BID/ RFP ADDENDUM

BID/ RFP TITLE: Admin Multi-Zone HVAC Replacement

## ADDENDUM 1

**MERCED COLLEGE  
ADMIN MULTI-ZONE REPLACEMENT**

3-WAY COIL CONNECTION      NTS      1

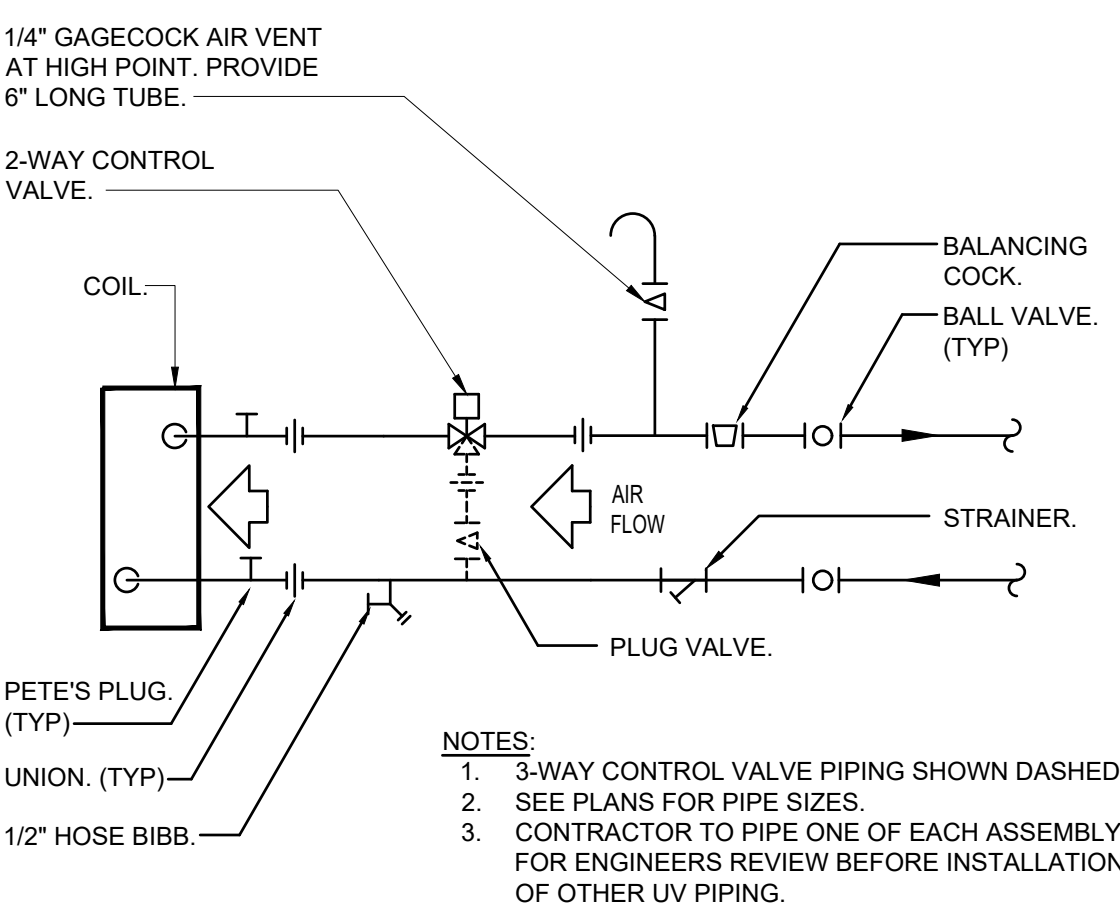
4. Please provide a coil connection detail for the chilled and hot water piping.

13. Please confirm whether control valves and actuators are required on the 3" Chilled Water Return and 3" Hot Water Return piping serving the new air handler. The drawings do not appear to show control valves or indicate their locations. Additionally, please advise whether 2-way or 3-way valves should be provided, if required?

**Response:** Refer to attachment AD01-03.

**Response:** Provide 3-way valves. See AD01-03.

Item 02: AD01-07

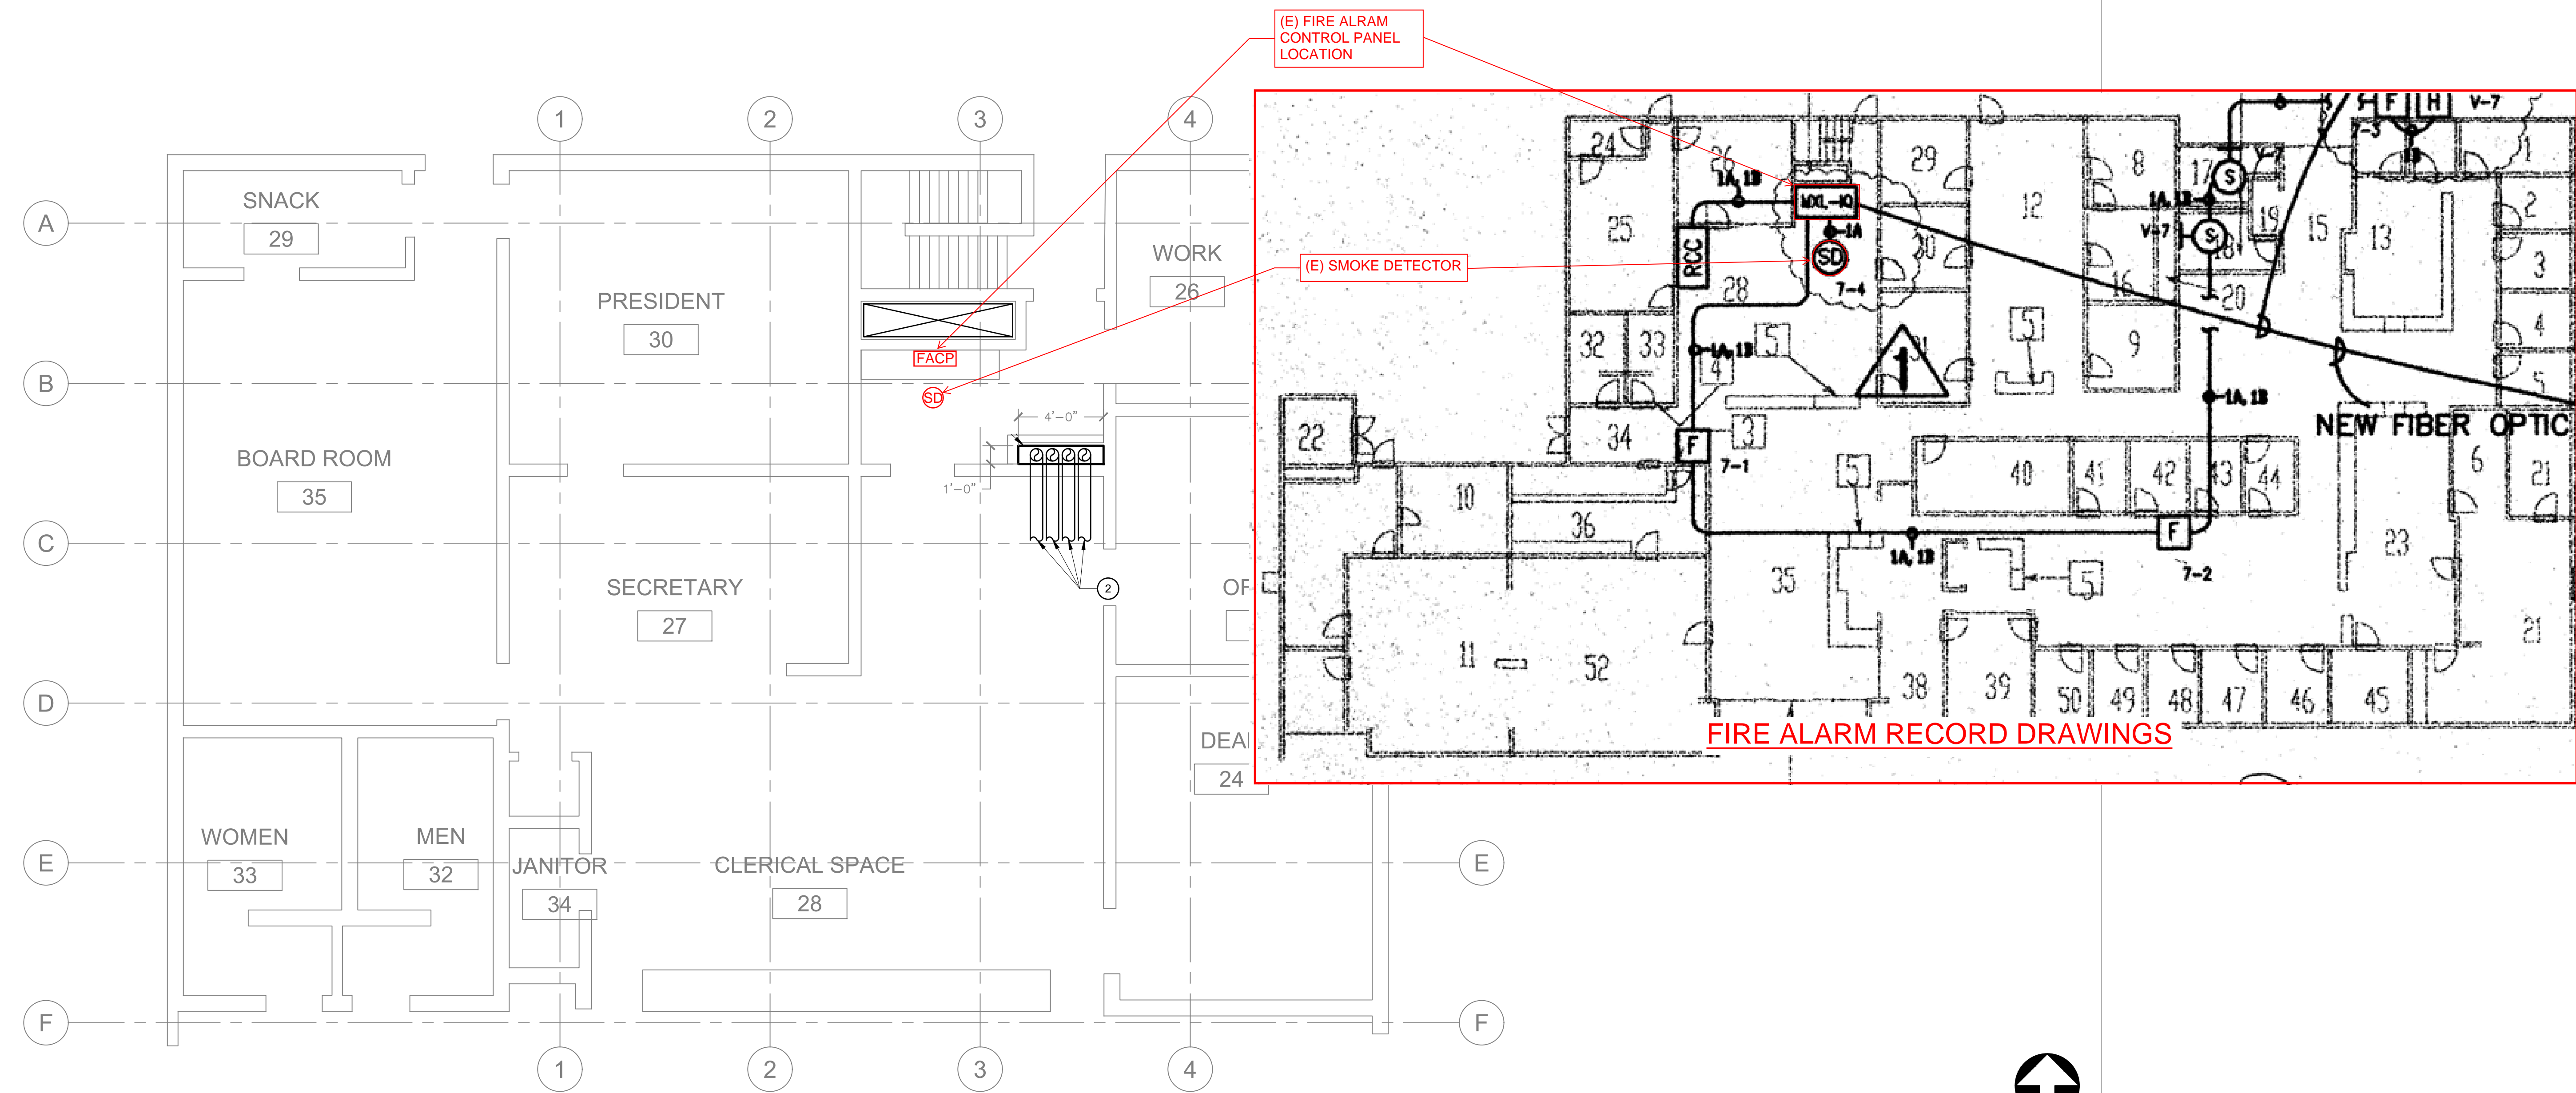
8. On sheet M500 in the electrical notes it calls out to intercept the nearest SLC device to tie in (2) new addressable fire alarm relays. Please provide the location of the nearest addressable fire alarm device in relation to the air handler penthouse.

**Response:** The nearest location to tie into the existing fire alarm system is either at the existing fire alarm control panel near the stairs or the smoke detector above the FACP. They are both about the same distance away from the air handler penthouse. Field verifying which one will be easiest to tie into. Refer to AD01-07.
